Historic Preservation Commission

Monday, November 22, 2021

Certificate of Appropriateness Addendum

Log Arch Replacement Project

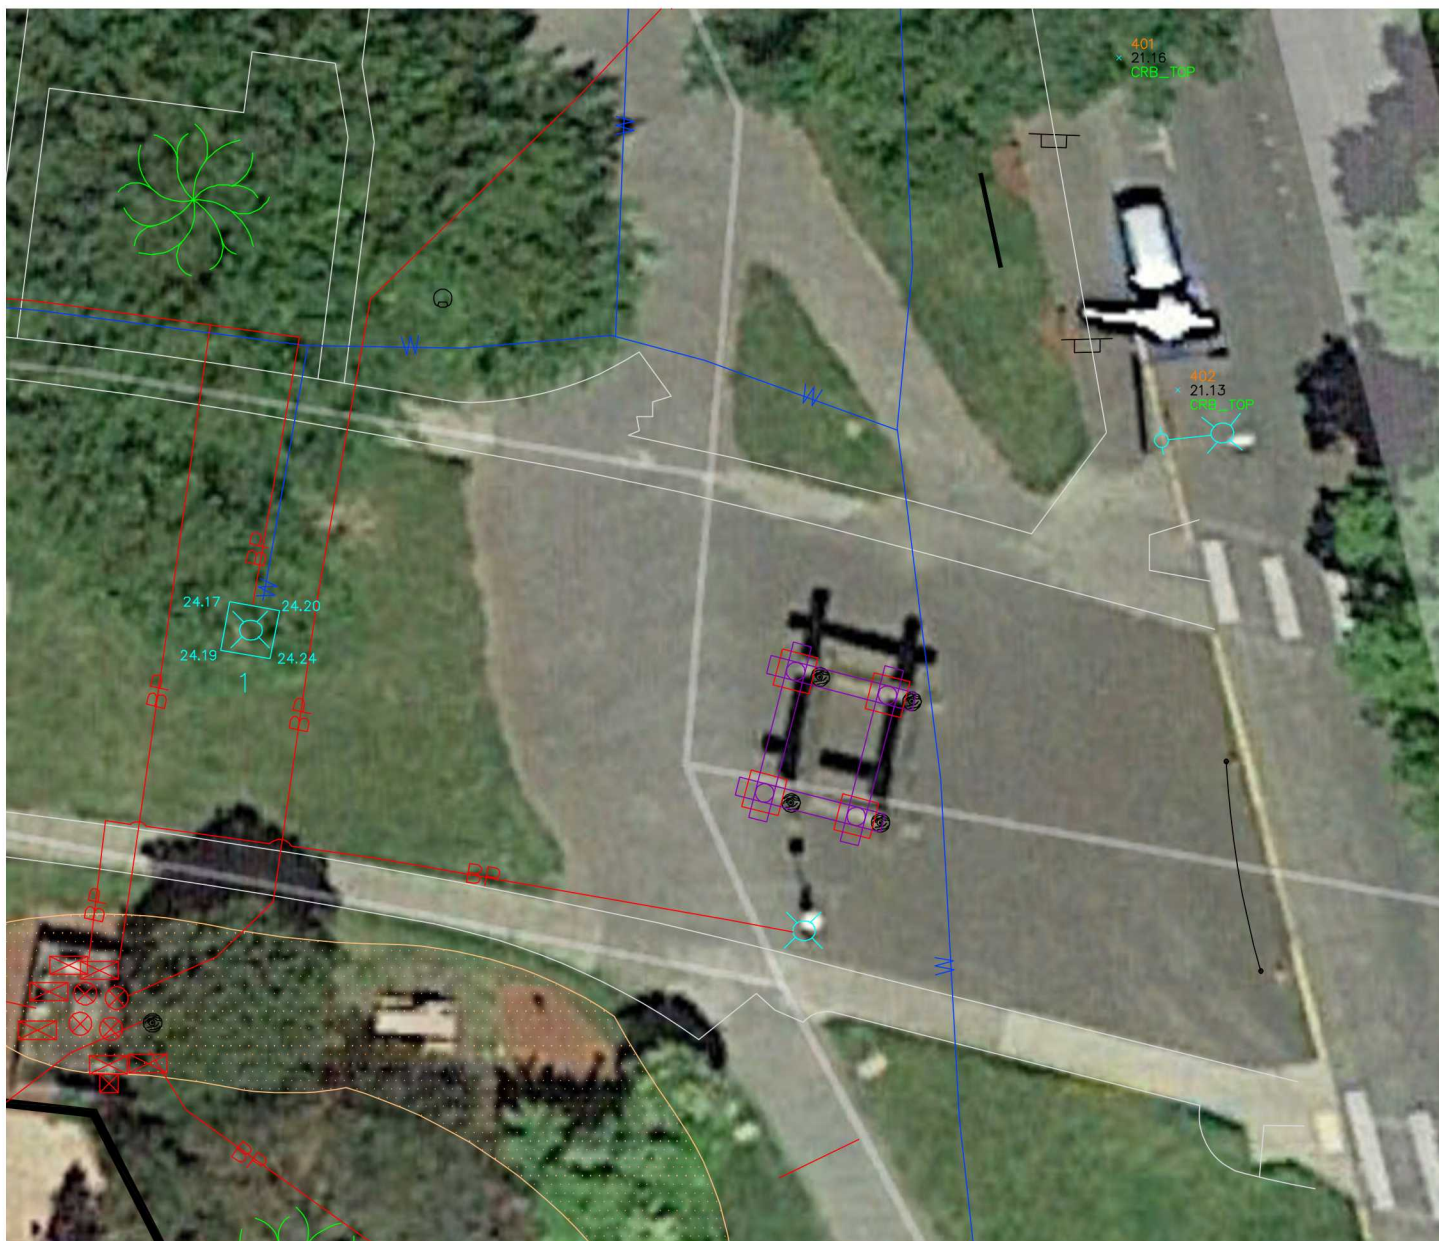
- The location of the arch was too close to the city water line noted in the CAD backgrounds of the park.
- The size of the arch in the initial plan drawings did not match the historical dimensions of the arch constructed in 1973.
- The proposed signage emulating the original Pageant of Progress “Welcome to Longview” sign needed to be presented for approval.

- A. As you will see in the attached drawing, we have moved the proposed location of the arch a little over 2’ to accommodate any work that might need to occur on the water line.

- B. The arch location drawing also reflects the revised dimensions, which match the historic dimensions of the log arch in that location. We have also provided revised drawings reflecting those new dimensions.
